## Product Change Notice (PCN)

PCN Number: PCN-0451176R-01

Product(s) Affected: PJ-046, PJ-046H

## Comparison plastic housing as below:

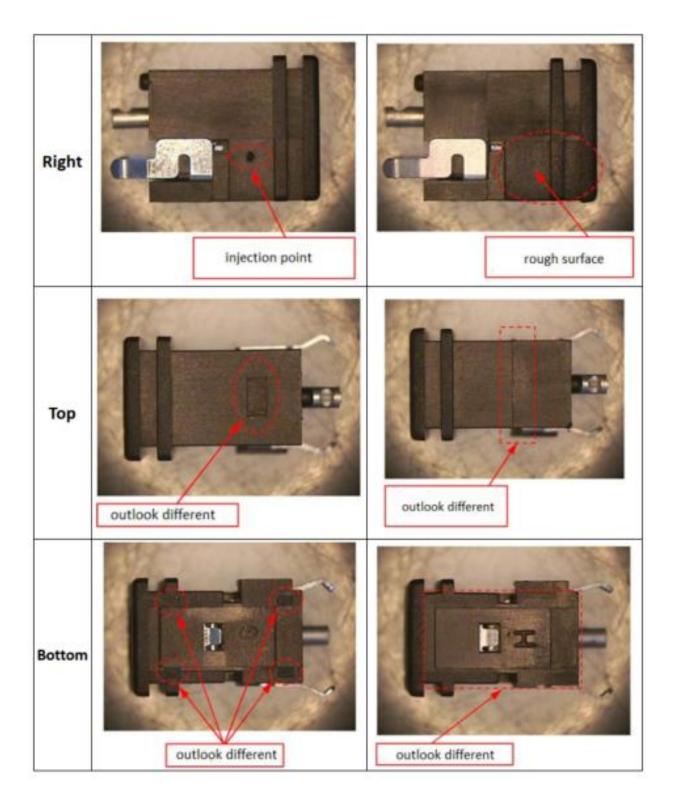
Reason(s) for Change: The existing mold of PJ-046 and PJ-046H (shared plastic mold) is unable to maintain an efficient production level. In order to maintain quality and lead-time of production, a new mold has been developed. We have taken this opportunity to optimize the product design and to enhance the quality of the overall process. The new mold will enhance the appearance and the electrical structure while maintaining fit, form, and function of the final product.

Description of Change: Photos of changes included below. PJ-046H center pin (pin 1) is changed from nickel plating to silver plating.
